State of New Mexico
 Energy, Minerals and Natural Resources

SUNDRY NOTICES AND REPORTS ON WELLS (DO NOT USE THIS FORM FOR PROPOSALS TO DRILL OR TO DEEPEN OR PLUG BACK TO A DIFFERENT RESERVOIR. USE "APPLICATION FOR PERMIT" (FORM C-101) FOR SUCH PROPOSALS.)		WELL API NO. 30-015-20920

2. Name of Operator Cambrian Management, Ltd		6. State Oil & Gas Lease No.
3. Address of Operator PO Box 272, Midland, TX 79702		7. Lease Name or Unit Agreement Name Fanning

EXECUTIVE SUMMARY WELLBORE DIAGRAM

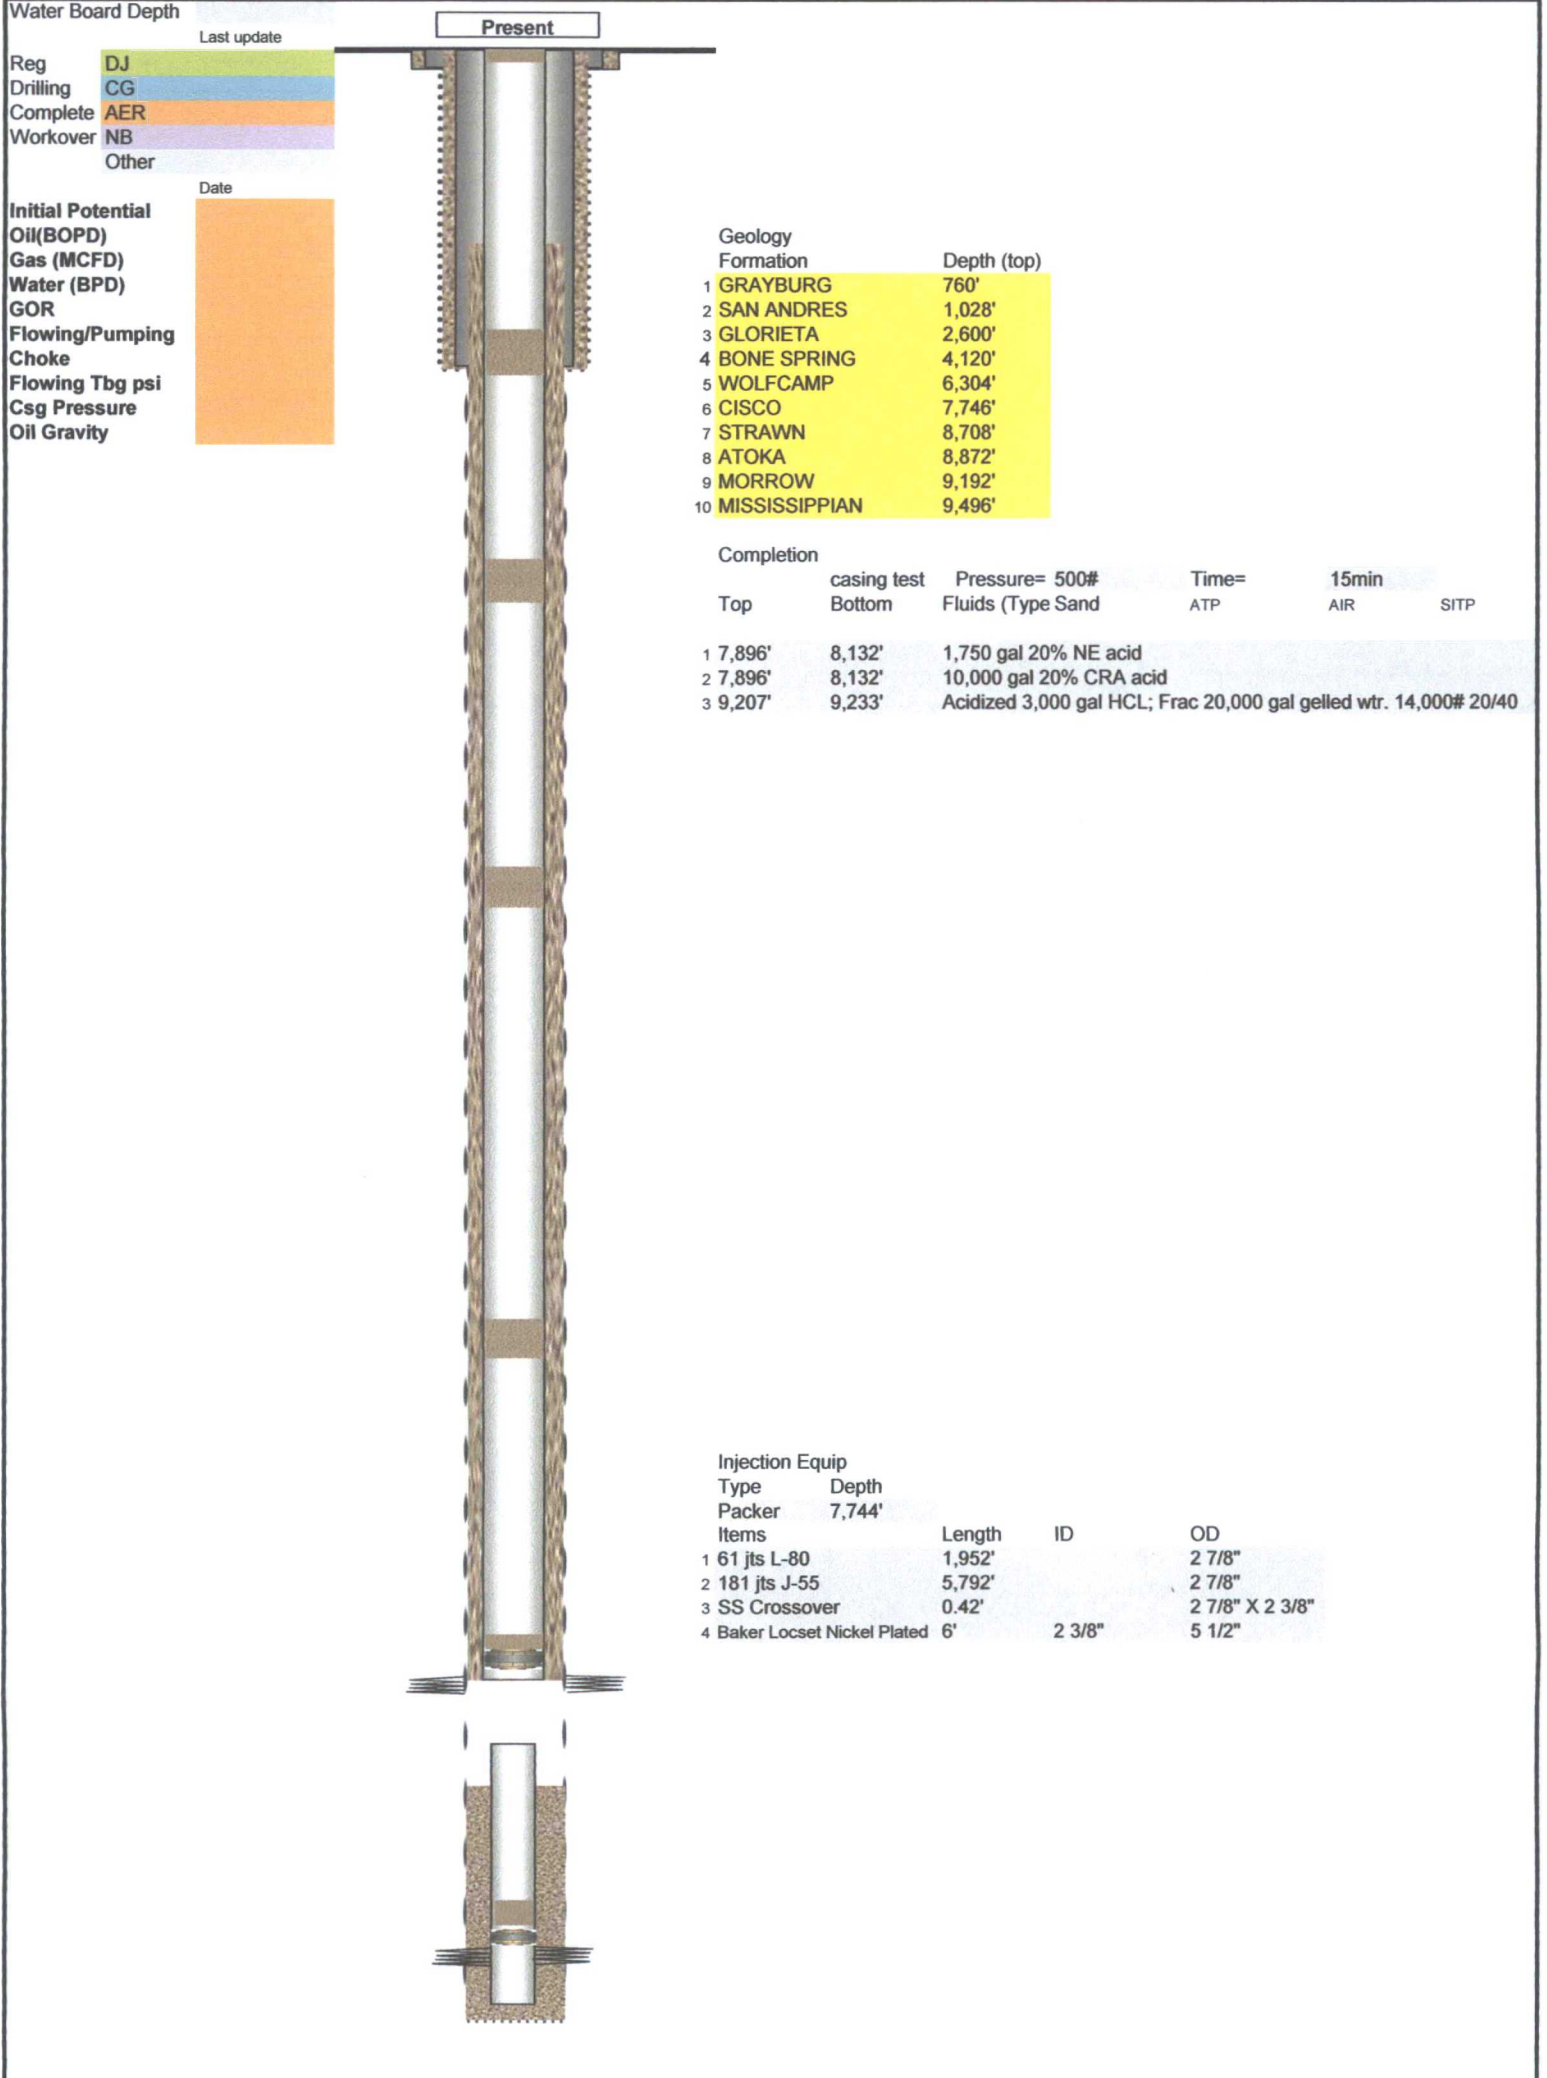
- 1) MIRU P&A Unit
- 2) Make proper connections to POOH w/tbg and pkr
- 3) RIH w/CIBP. Set @ 7850' 100' See COA (17+18)
- 4) RIH w/workstring, set 35' (5sx) Class H cmt on top of CIBP. WOC & TAG
- 5) Cmt 25sx from 6350'-6150' WOC & Tag
- 6) Cmt 25sx from 4150'-3950' WOC & Tag
- 7) Cmt 25sx from 2650'-2450' WOC & Tag
- 8) Perf and sqz 25 sx cmt 1550'-1350' across surface shoe. WOC & Tag
- 9) Cmt from 10' to surface (1.5 sx) Perf + sqz to surf 250'
- 10) Cut off wellhead. Weld plate. Install plugged well marker
- 11) Clean and remediate location
